**SUBJECT: CRENSHAW/LAX TRANSIT CORRIDOR PROJECT**

**ACTION: PROJECT DEFINITION CHANGES IN CEQA ADDENDA**

Design Changes - Environmental Technical Memorandum

**Figure 3**  
 Faithful Central Bible Church Mid-Block Pedestrian Undercrossing

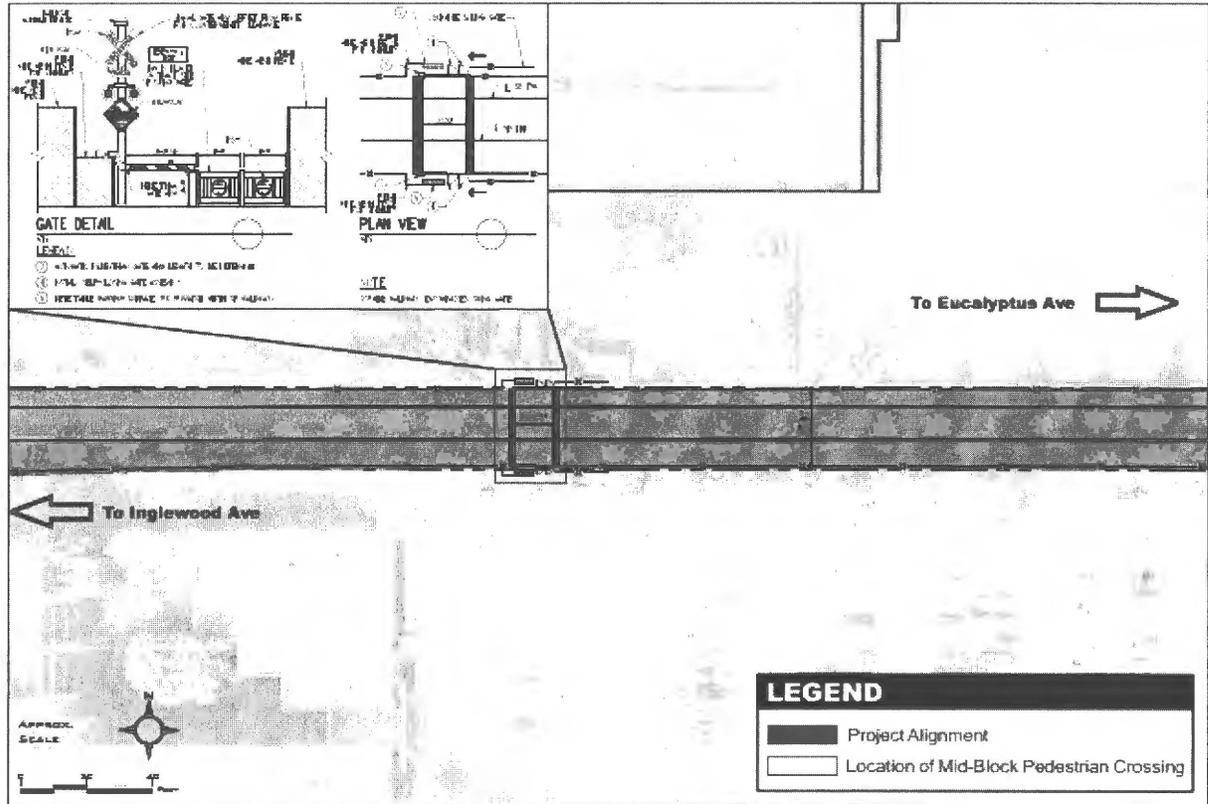
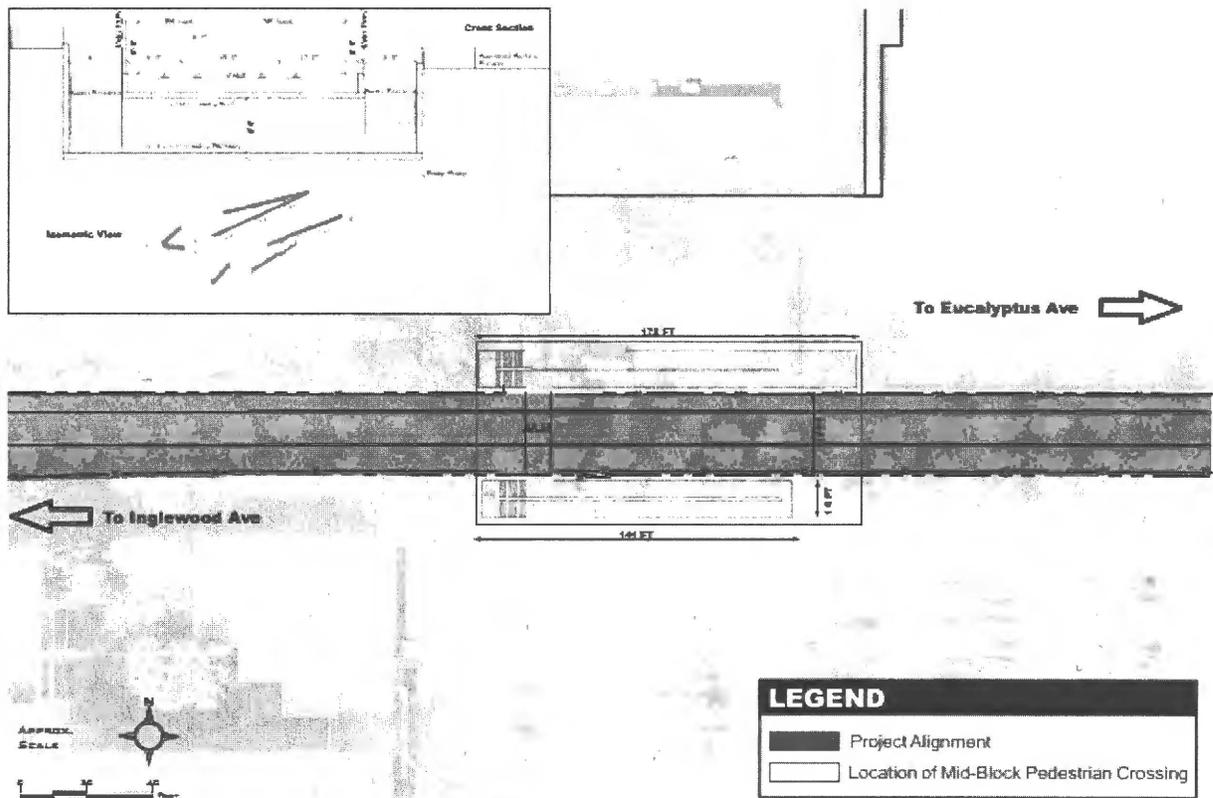
This proposed design change would convert the mid-block at-grade pedestrian crossing of the LRT tracks at the Faithful Central Bible Church (FCBC) location, approximately 350 feet west of Eucalyptus Avenue, to a mid-block pedestrian undercrossing at the same location.

The proposed design change would create a pedestrian undercrossing rather than an at-grade pedestrian crossing at the same mid-block location. This proposed design change would enable church users to walk from the parking lot to the Tabernacle through a pedestrian undercrossing (or tunnel). This design change allows for increased pedestrian safety as church visitors are routed beneath the LRT tracks and avoid pedestrian queuing and pedestrian-vehicle conflict. The church would maintain control over access to the pedestrian undercrossing, which would be locked when not in use.

The mid-block pedestrian undercrossing at FCBC would cost an additional \$2.2 million to implement when compared to the mid-block at-grade pedestrian crossing at the same location, which has an estimated cost of \$200,000. A preliminary drawing of the proposed mid-block pedestrian undercrossing is shown in **Figure 3**.

**Figure 4**  
 La Brea Avenue Grade Separation and Station

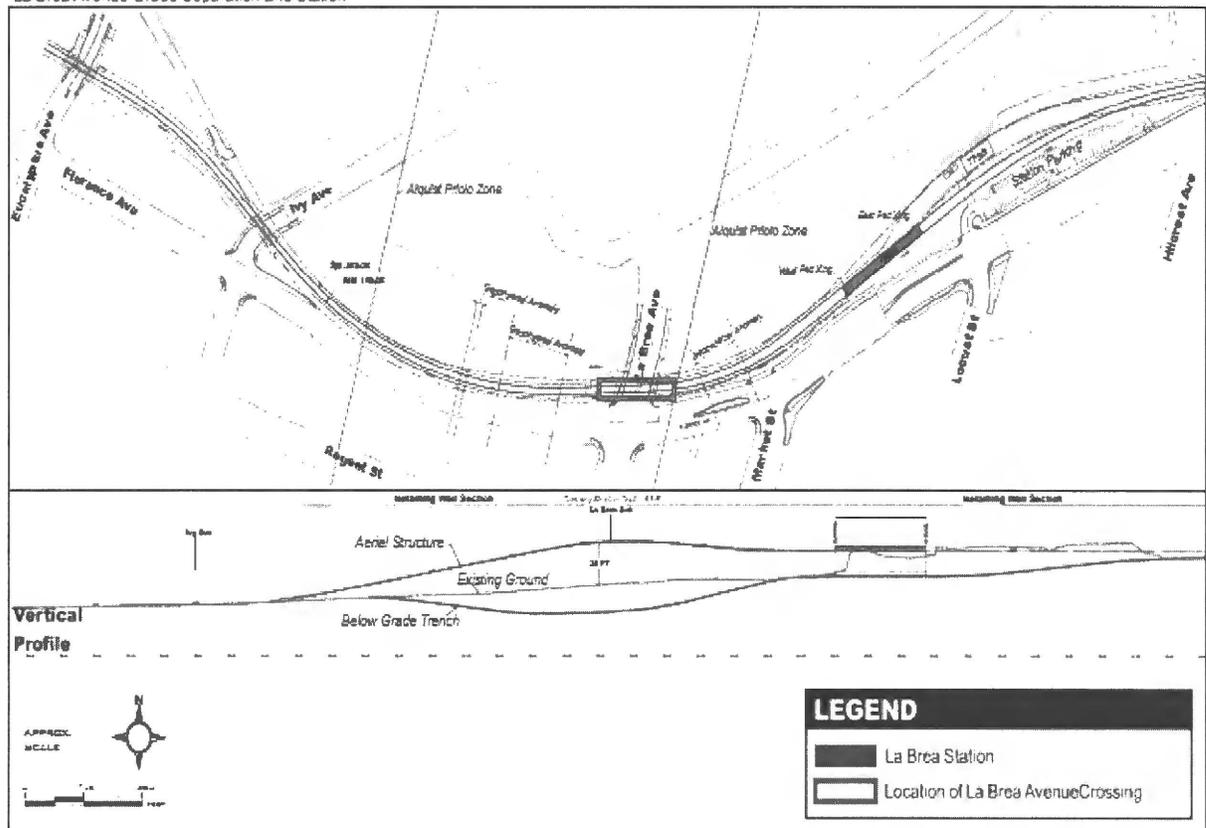
This proposed design change would convert the grade separation at La Brea Avenue from a below-grade LRT crossing to an aerial guideway. The below-grade configuration referred to in this memo was cleared as the approved project by the LACTMA board. The environmental record also examined an aerial configuration over La Brea Avenue in the DEIS/DEIR. This aerial segment was considered part of the Base LRT Alternative, was assumed during circulation of the DEIS/DEIR, and adopted as the Locally Preferred Alternative by the LACMTA Board.

During the advanced conceptual design phase of the project, it was determined that potential seismic constraints, from the Newport-Inglewood Fault Zone, would prohibit the construction of a station at or immediately adjacent to La Brea Avenue.

As part of the design change, the Florence/La Brea Station, located in the same location approved as part of the project, is proposed to be at-grade and level with Florence Avenue, instead of approximately 17-feet below Florence Avenue. This design change would also include retaining walls approaching each side of La Brea Avenue. **Figure 4** depicts the aerial guideway design change. The cost savings associated with this option would be approximately \$10 million.
